INCH-POUND

MIL-C-62204B(AR)
AMENDMENT 2
30 August1993
SUPERSEDING
AMENDMENT 1
9 NOVEMBER 1987

CIRCUIT CARD ASSEMBLY: 11743281, DISPLAY DRIVER

This amendment forms a part of MIL-C-62204B(AR), dated-30 June 1981, and is approved for use by the U.S. Army Armament, Munitions, and Chemical Command, Department of the Army, and is available for use by all Departments and Agencies of the Department of Defense.

FIGURE 7. Malfunction light return and blanking output waveforms.

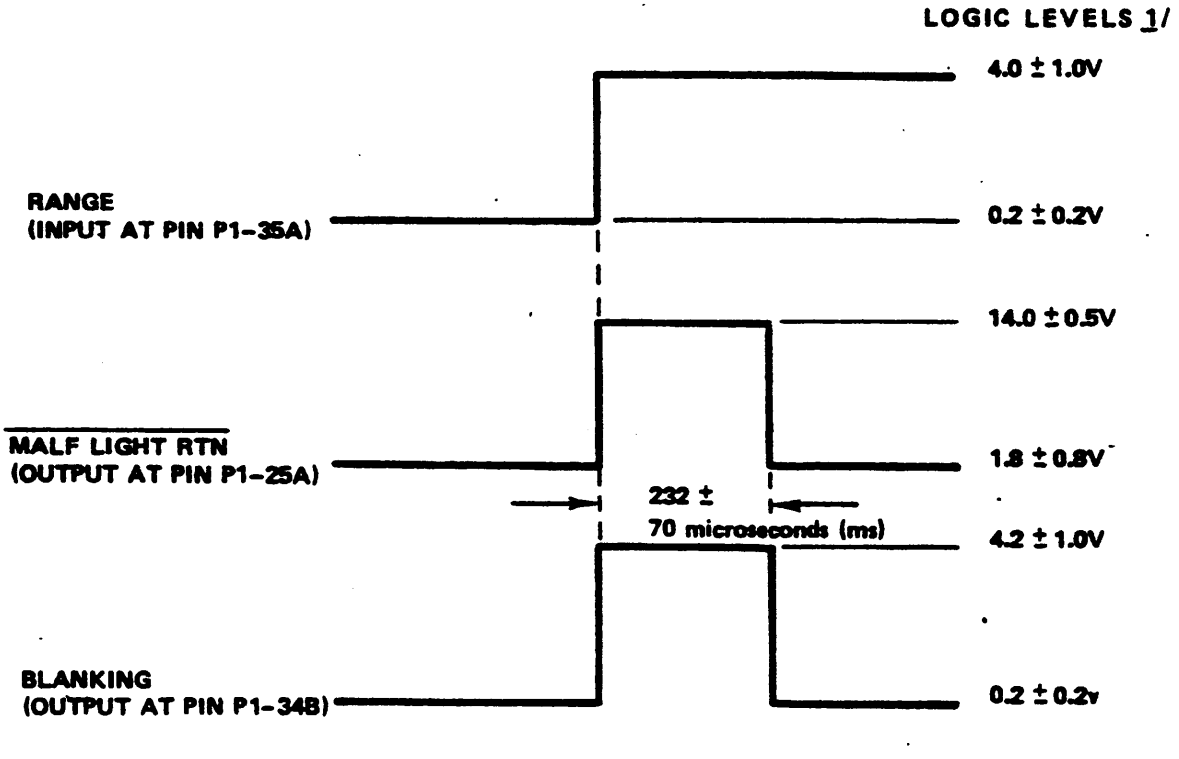
* Figure 7: Delete "232 ± 70 microseconds (ms)" and substitute "232 ± 70 milliseconds (ins)"
